Memo

To: The Atherton Planning Commission
From: Sally D Bentz-Dalton, Town Arborist
CC: Gerry Martin, Assistant Planner
Date: 4/28/25
Re: Tree Protection Zone (TPZ) Exception 94 Palmer

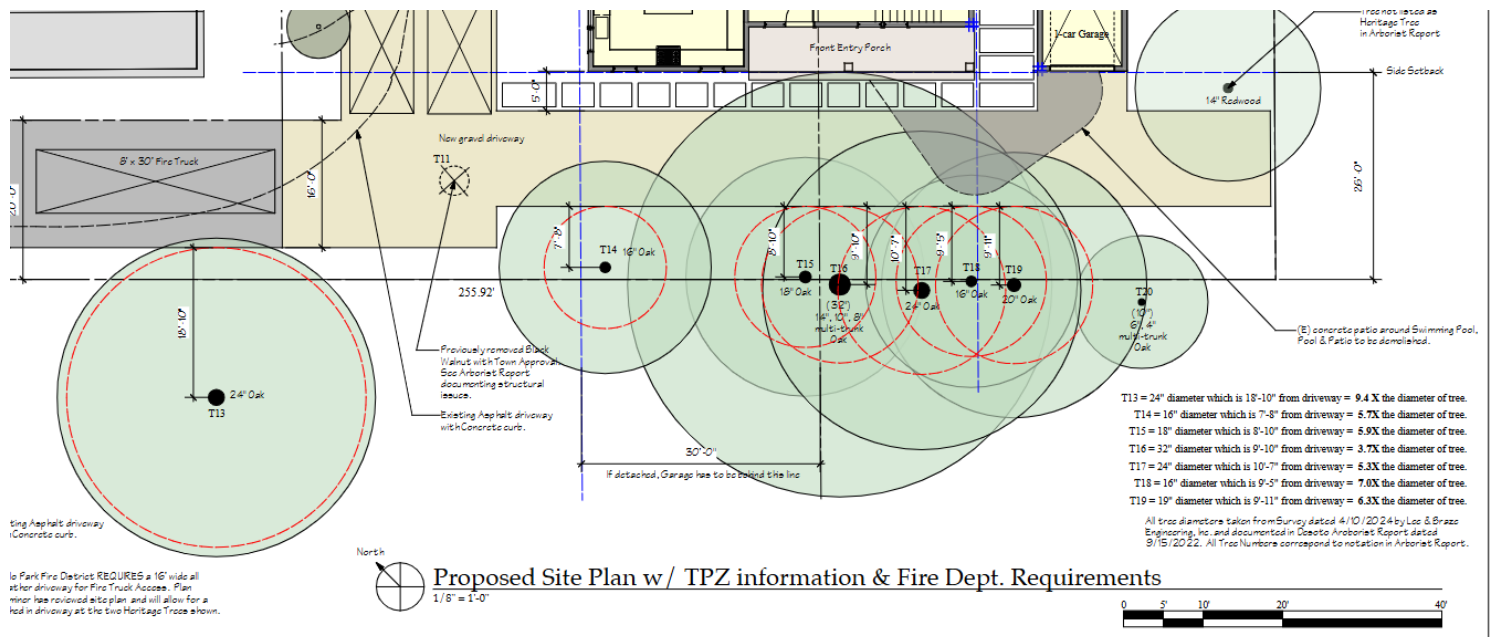
The applicant is applying for TPZ exceptions for the following:

T14 = 16" diameter which is 7'-8" from driveway = 5.7X the diameter of tree.
T15 = 18" diameter which is 8'-10" from driveway = 5.9X the diameter of tree. Shared.
T16 = 32" diameter which is 9'-10" from driveway = 3.7X the diameter of tree. Shared/ Neighbor's tree.
T17 = 24" diameter which is 10'-7" from driveway = 5.3X the diameter of tree. Neighbor's tree.
T18 = 16" diameter which is 9'-5" from driveway = 7.0X the diameter of tree. Shared.
T19 = 19" diameter which is 9'-11" from driveway = 6.3X the diameter of tree. Neighbor's tree.

T14 = 16" diameter which is 7'-8" from driveway = 5.7X the diameter of tree.
T15 = 18" diameter which is 8'-10" from driveway = 5.9X the diameter of tree.
T16 = 32" diameter which is 9'-10" from driveway = 3.7X the diameter of tree.
T17 = 24" diameter which is 10'-7" from driveway = 5.3X the diameter of tree.
T18 = 16" diameter which is 9'-5" from driveway = 7.0X the diameter of tree.
T19 = 19" diameter which is 9'-11" from driveway = 6.3X the diameter of tree

1. The Applicant must provide outreach to the neighbor owning trees subject to this request, ensuring that they are aware of the project scope, prior to issuance of a related building permit.
2. The Project Arborist is required to be on hand during excavation for the demo of the existing driveway and excavation of new driveway.
3. Excavations are required to be performed carefully and by hand 8x away or less to avoid tearing or pulling roots.
4. The Project Arborist or their designated person should cut all roots larger than 1 inch in diameter with a sharp saw on the side of the excavation closest to the tree (s).
5. No roots over 2" to be cut.
6. All work in this are required to be documented in the quarterly arborist reports.
7. Install Easypave grid to as shown in submitted detail.
